### **I-405, SR520 to SR522 Stage 1 (Kirkland Stage 1)**

**Table of Contents**  
**I-405, SR520 to SR522 Stage 1**  
**Design Deviation Papers**

### Design Deviation #1

NB I-405 Superelevation Transition Location

Limited Access Design Deviation  
Exhibit 4  
Alt A – Buy Additional Access

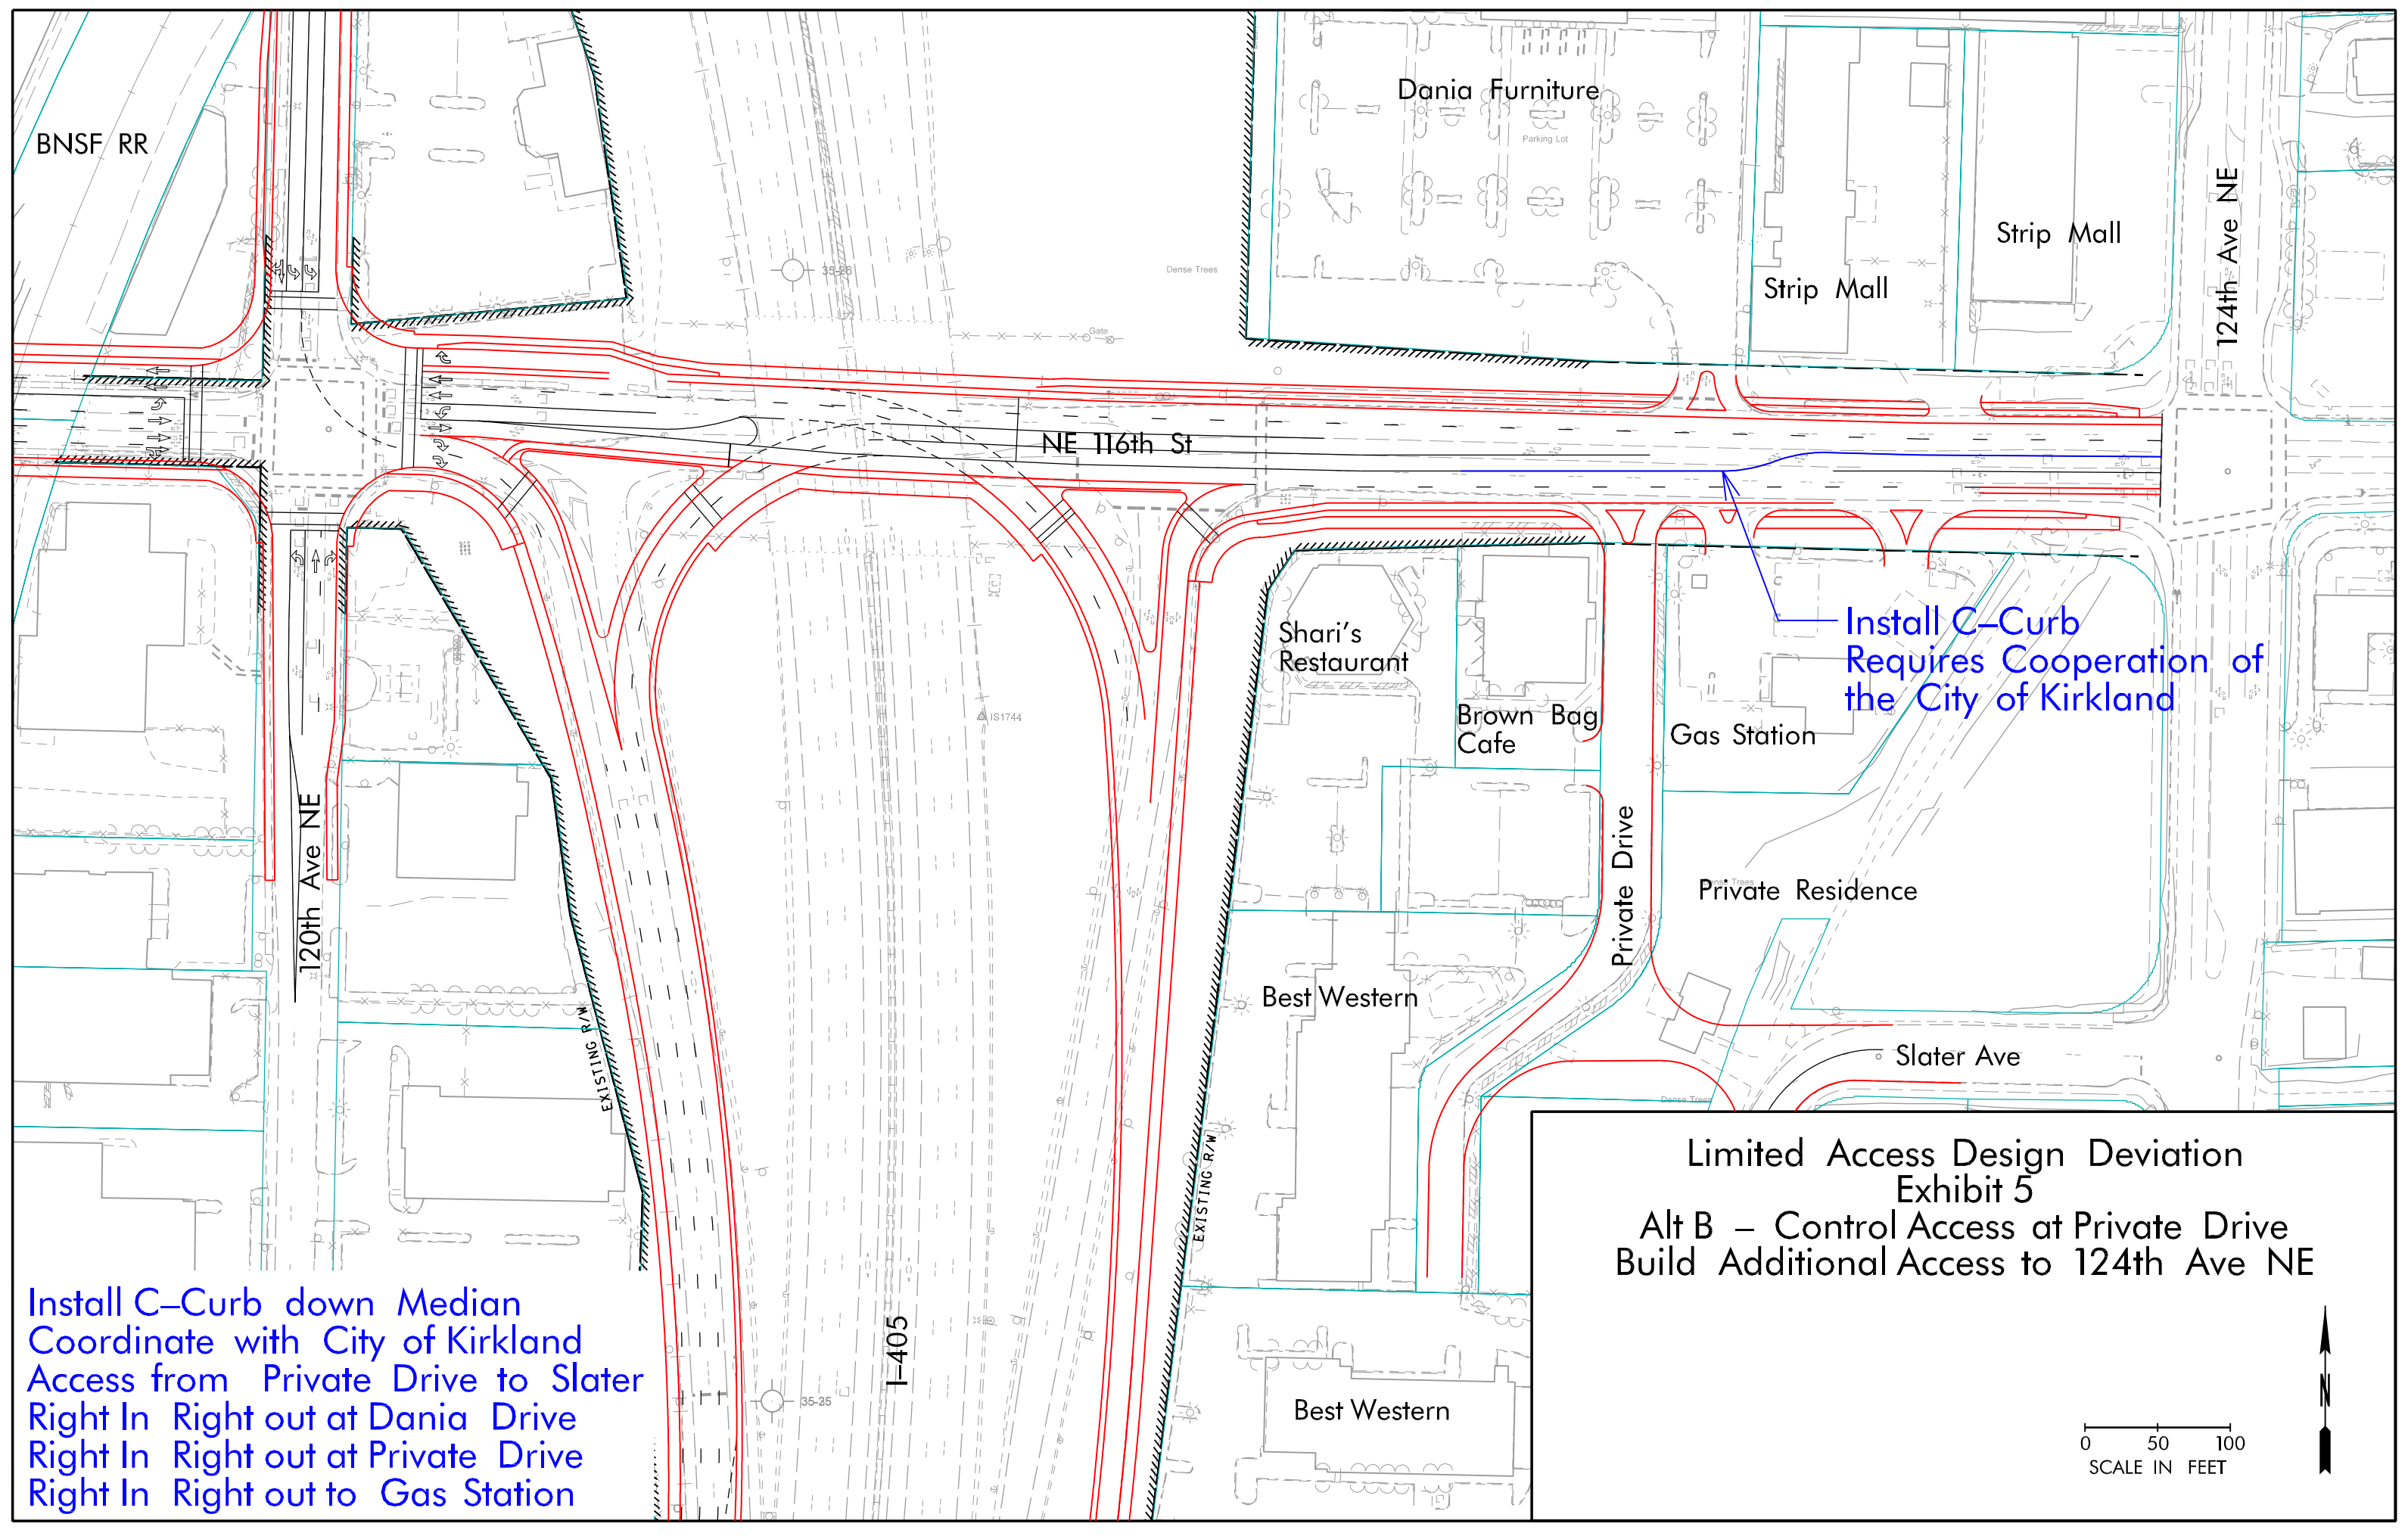
*Alternative A Buy Additional Access Control (Exhibit 4)* – Rebuild the existing half-diamond interchange as a half-SPUI, close the driveways west of the interchange and purchase approximately 65 feet of additional full access control east of the NB off ramp. Although the SPUI ramp terminal is only slightly east of the existing ramp terminal (Exhibit 3), the additional 65 feet is necessary because the reference point from which limited access is measured changes when turning movements are split by an island. The shared driveway and the driveway to Dania furniture would be affected by this option. However, Dania could rebuild their driveway, narrowing it by 5 feet, to avoid being constricted by WSDOT access control requirements. The western gas station driveway would be just beyond the new limited access boundary and therefore is out of WSDOT limited access control.

This alternative would benefit the community by helping to avoid conflicts near the interchange. However, this alternative would cost up to \$20 million dollars to purchase out the 4 businesses. In addition the half-SPUI yield right to an add lane operates much the same as the existing half- diamond configuration does today.

Buying additional limited access (Alternative A, Exhibit 4) was not considered reasonable given that the accidents in this location don't warrant additional control and that the additional limited access would cost close to \$20 million dollars if all 4 businesses along the private drive were purchased. The owners along this private drive were approached; however they are not interested in any voluntary changes. Therefore

Limited Access Design Deviation  
Exhibit 5  
Alt B – Control Access at Private Drive  
Build Additional Access to 124th Ave NE

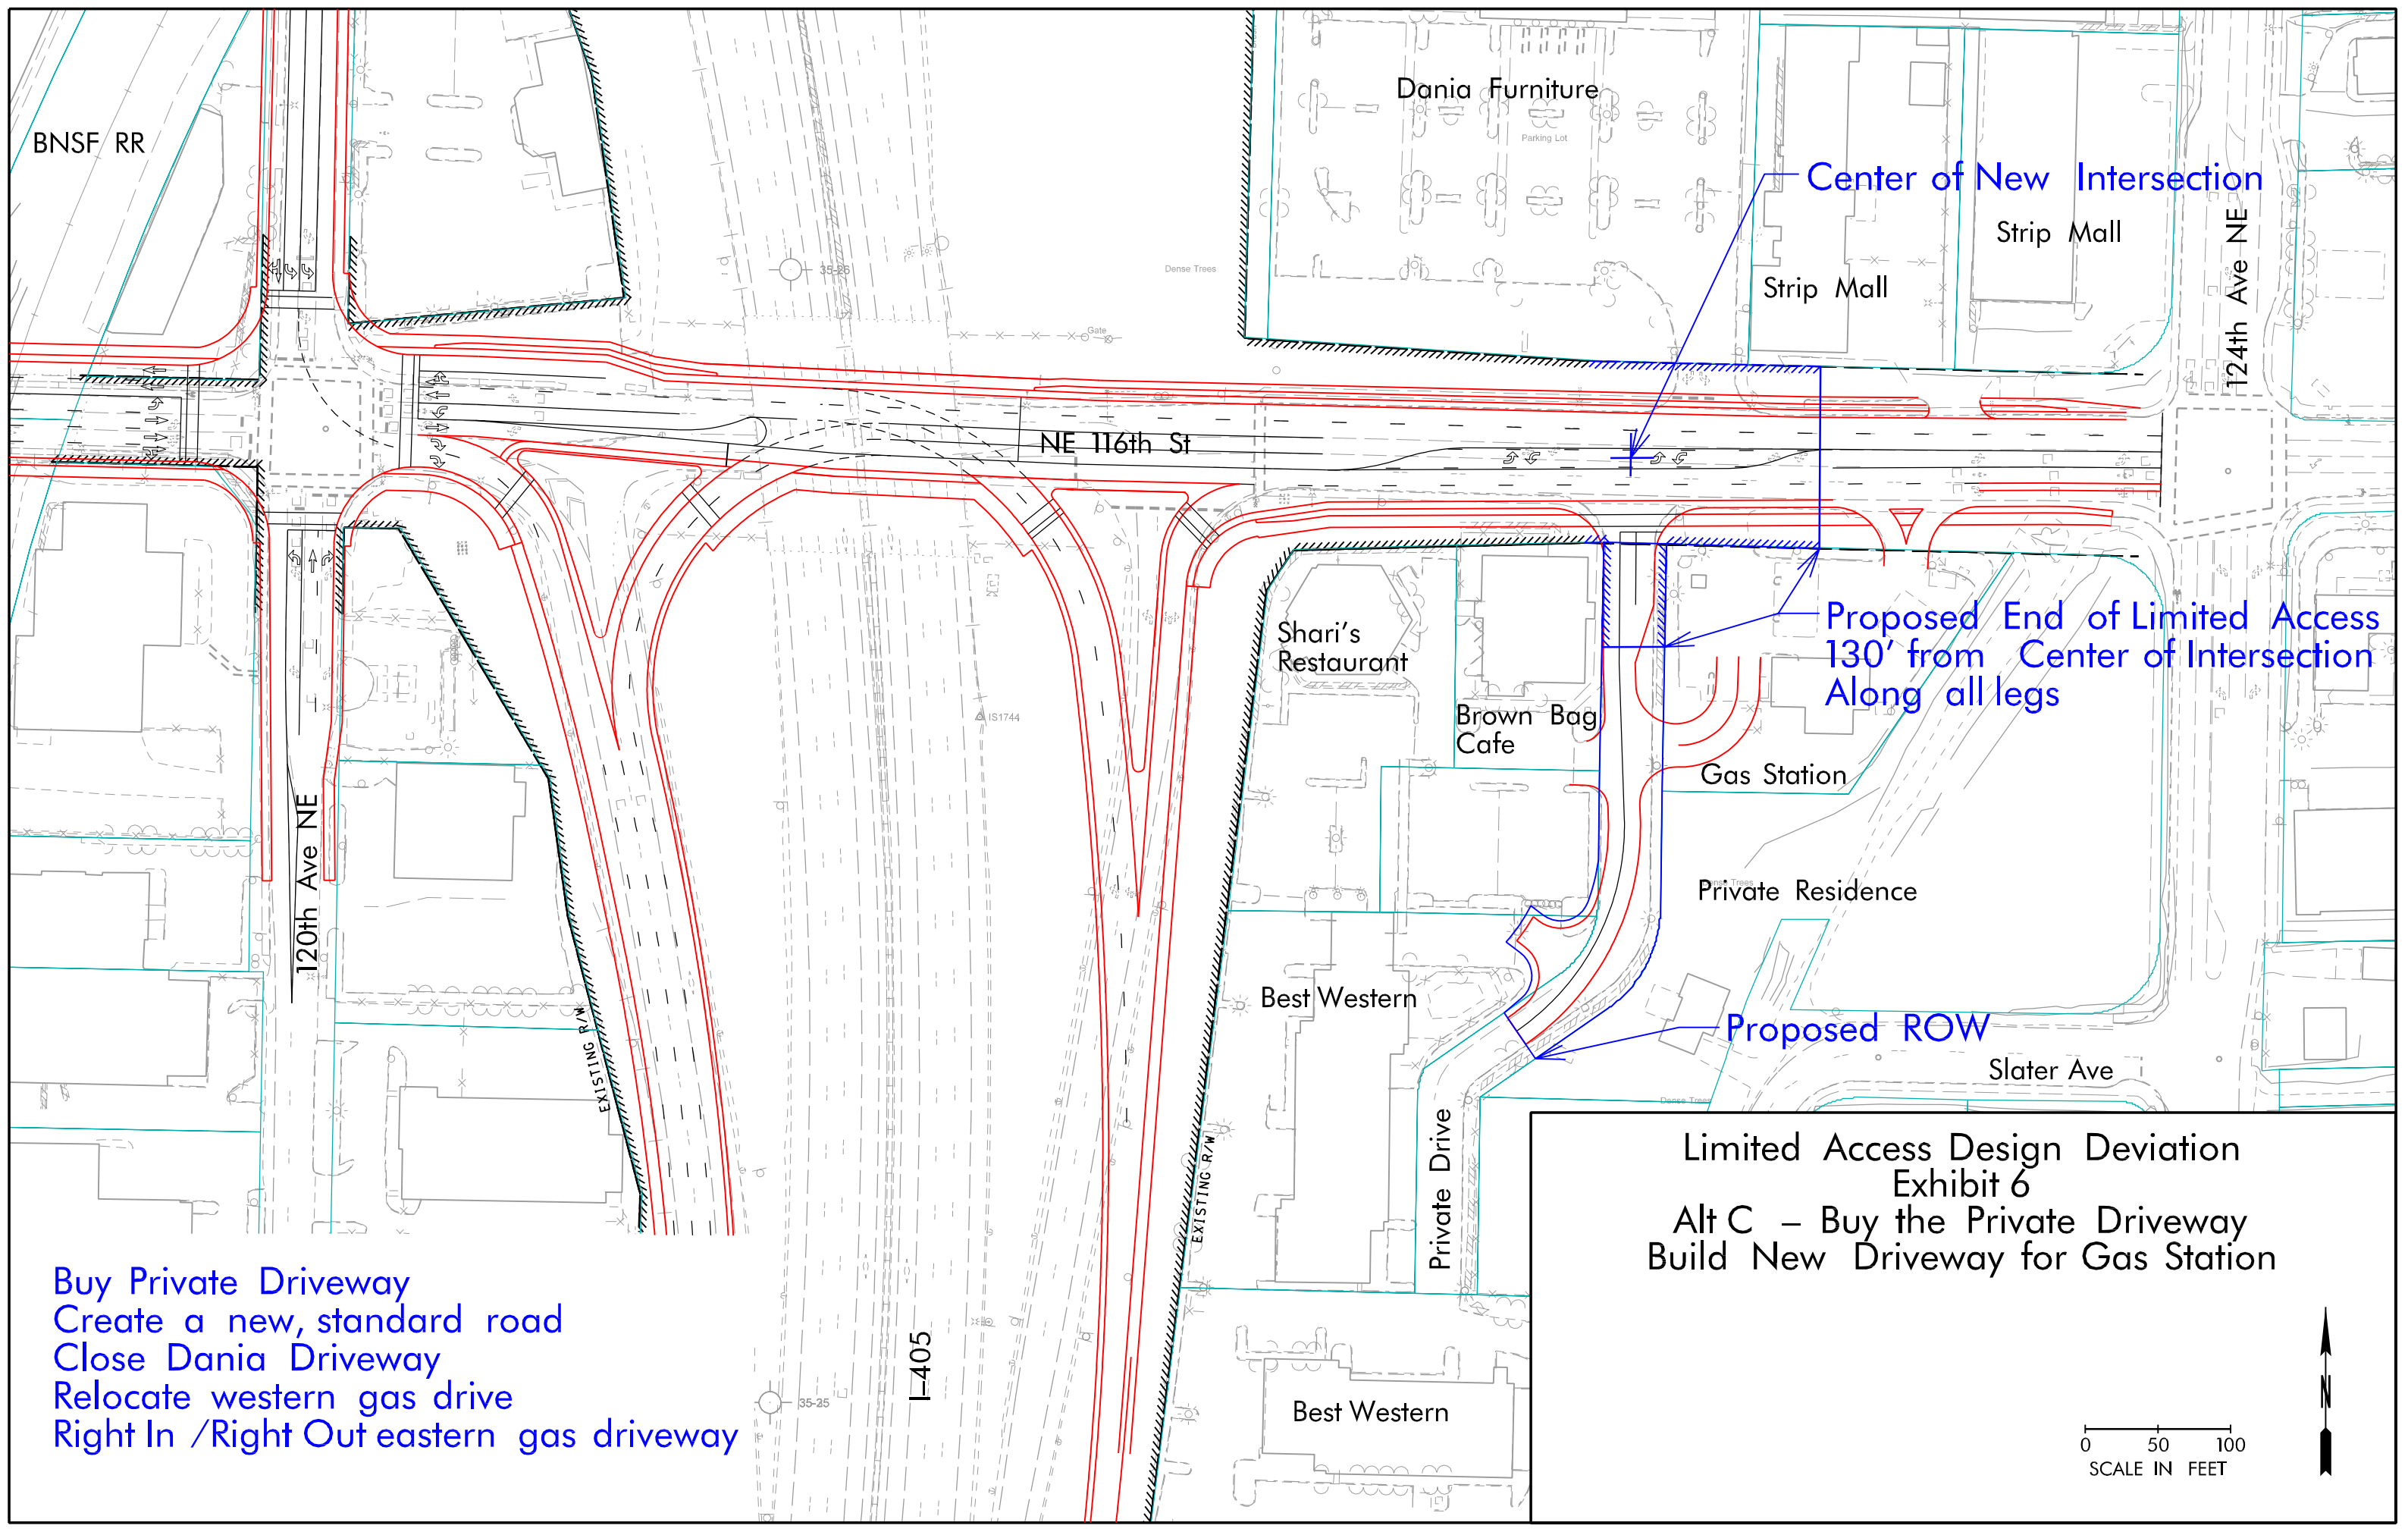
*Alternative B Build an access from private driveway to 124<sup>th</sup> (Exhibit 5)* – Manage access, without acquiring additional limited access, along NE 116<sup>th</sup> St. by building a new access from the back of the private driveway exiting onto Slater Avenue. This new connection would require purchasing additional ROW and may involve taking a church rectory. Current congestion on Slater Ave and 124<sup>th</sup> Ave NE may require additional mitigation due to the increased traffic. Right in – right out access to NE 116<sup>th</sup> St would be provided for the private driveway, both gas station driveways and Dania furniture, with all other traffic routed to 124<sup>th</sup> Ave NE. C-curb would be installed with cooperation from the City of Kirkland to enforce the right in right out access. An exit from the back

This alternative would give the businesses right in right out access to NE 116<sup>th</sup> St. causing some travelers a more circuitous route through a more congested 124<sup>th</sup> Ave. NE. In addition, creating an exit from the shared driveway onto Slater Avenue presents potential legal and traffic problems. Driveway access onto Slater Avenue would require a significant rebuild of the improvements the City of Kirkland will make as a part of the 124<sup>th</sup> Ave NE project. The intersection of Slater Ave and NE 124<sup>th</sup> St is not signalized. Vehicles making a left turn from Slater must cross two lanes of traffic and merge into an existing queue that extends several hundred feet south of Slater Ave. NE 124<sup>th</sup> Ave has high traffic volumes and severe congestion during peak hour. Even with the City's planned improvements, the congestion along this road will not be eliminated. This alternative would cost \$1 million to purchase the land to build the alternative roadway.

Controlling access to the private drive (Alternative B, Exhibit 5) allowing only right in and right out and building an additional access for the private drive onto 124<sup>th</sup> Ave NE didn't seem to make sense from a traffic standpoint. Traffic along 124<sup>th</sup> Avenue NE is much more congested than NE 116<sup>th</sup> Street and without signal control at Slater Avenue making left movements would be difficult and problematic. In addition, this new roadway would tear out portions of what the City is currently building to improve this intersection. This alternative was approximately \$1 million.
